# TMC SPECIFICATION NO. S-601

TITLE: SBE-2 ALDC MODIFICATION KIT (TMC NO. KIT-115)

To provide an ALDC line into the SBE-2.

FIGURE 1\*

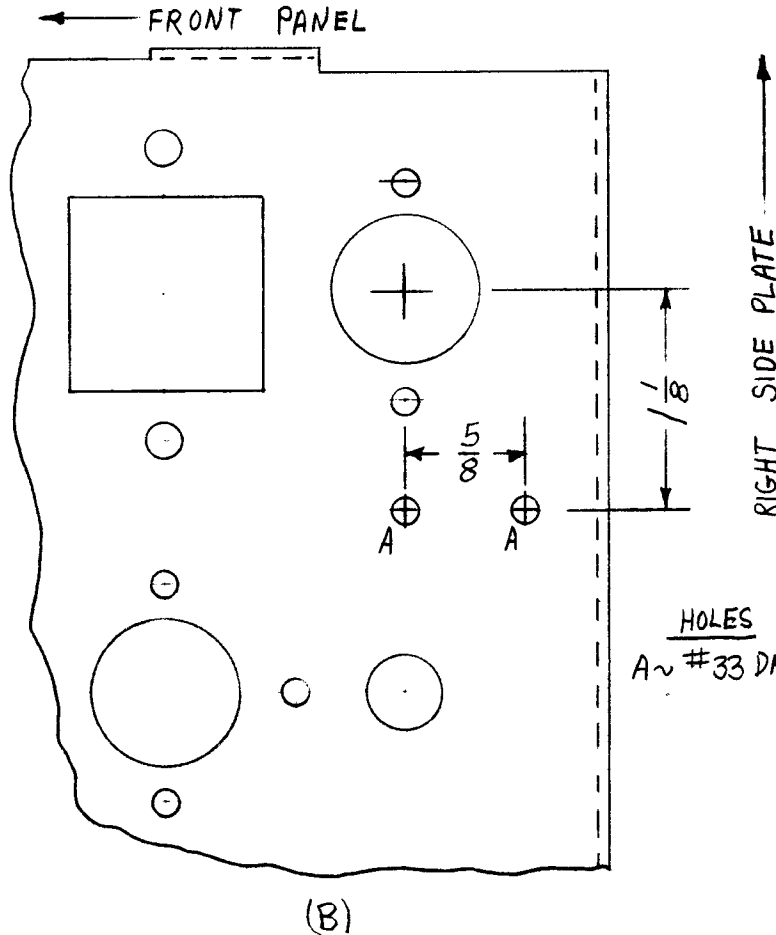
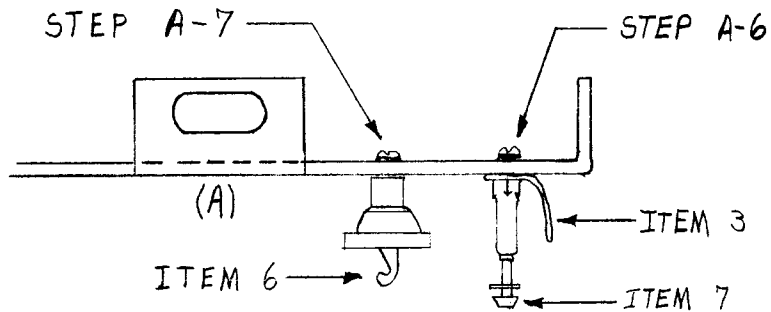
- A. With the SBE-2 on the bench and all power disconnected, the following procedure is to be followed.
  1. Remove top and bottom dust covers.
  2. Unsolder the grounded ends of R192 and R193.
  3. Mark appropriate spot on the chassis for the drilling of the two holes used for mounting of the turret terminal and button capacitor (hole location dimensions shown in Figure 1).

5. Clean SBE-2 of all metal shavings resulting from the drilling. Be sure that nothing is shorting.
6. Mount the turret terminal (Item 7) and locking terminal lug (Item 3) by use of the 4-40 hardware (Items 8&10) as shown in Figure 1.

7. Mount the button capacitor (Item 6) by use of the 3-48 hardware (Items 9 & 11) as shown in Figure 1.
8. Slide the proper amount of insulation (Item 12) over the loose ends of R192 and R193 and connect each resistor to the button capacitor (Item 6). Do not solder.

FIGURE 2  
COMPONENT LAYOUT

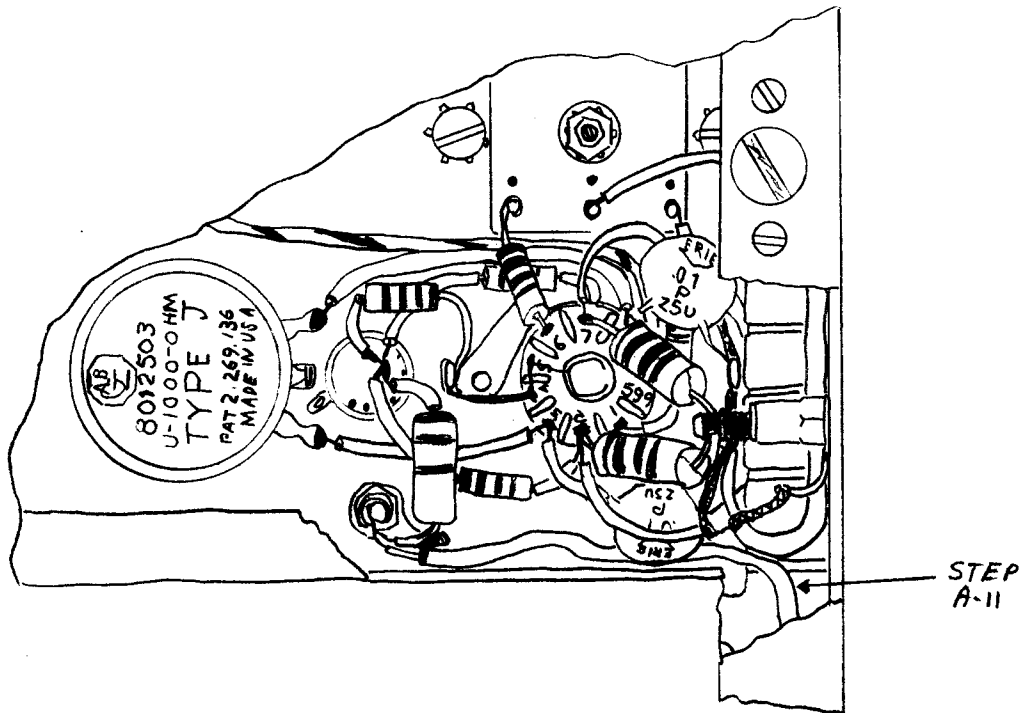
11. Insert RF cable (Item 1) through hole found on RF shield wraparound as shown in Figure 2.
12. Connect center conductor of RF cable to turret terminal (Item 7). Solder the connection.

18. Affix instruction nameplate (Item 15) directly to the Bottom of the connector which has just been installed (refer to Figure 3).
19. Check modifications to see that everything conforms with Figure 2.

FIGURE 3 \*  
HOLE LOCATING VIEW

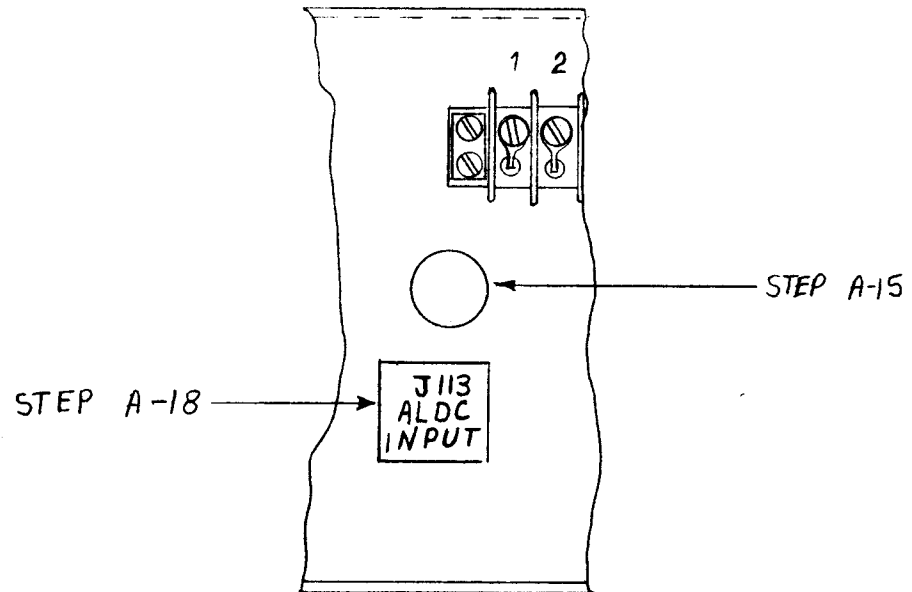
15. Mount the RF connector (Item 2) in the hole found in the rear of the SBE-2 as shown in Figure 3. Mount the solder lug (Item 16) over the rear of the RF connector. Proceed now to tighten the locking nut by use of the 1/2 inch open end wrench.

FIGURE 4  
SCHEMATIC CHANGES

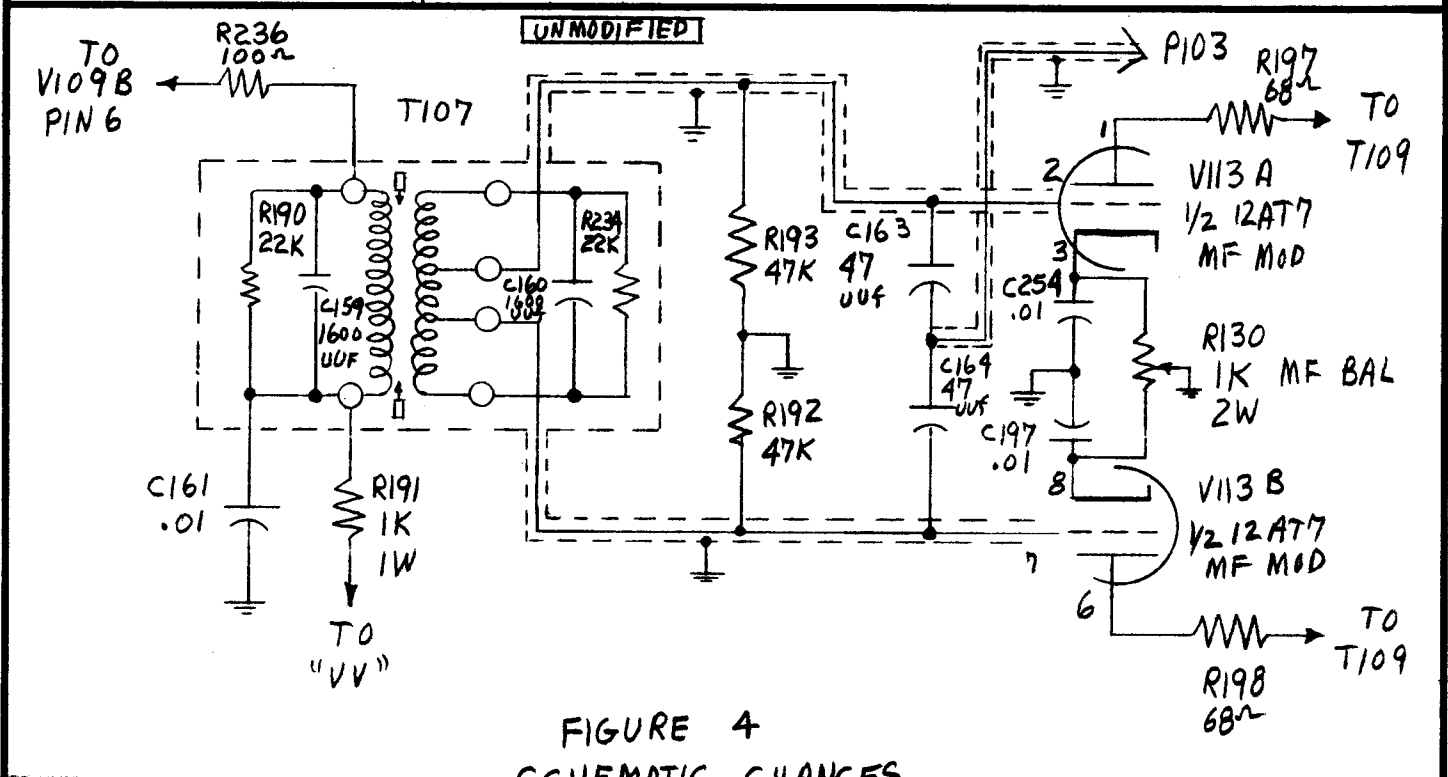
20. See Figure 4 for schematic diagram.
21. Replace the top and bottom dust covers, after the SBE-2 has been inspected for proper installation of the ALDC modification.
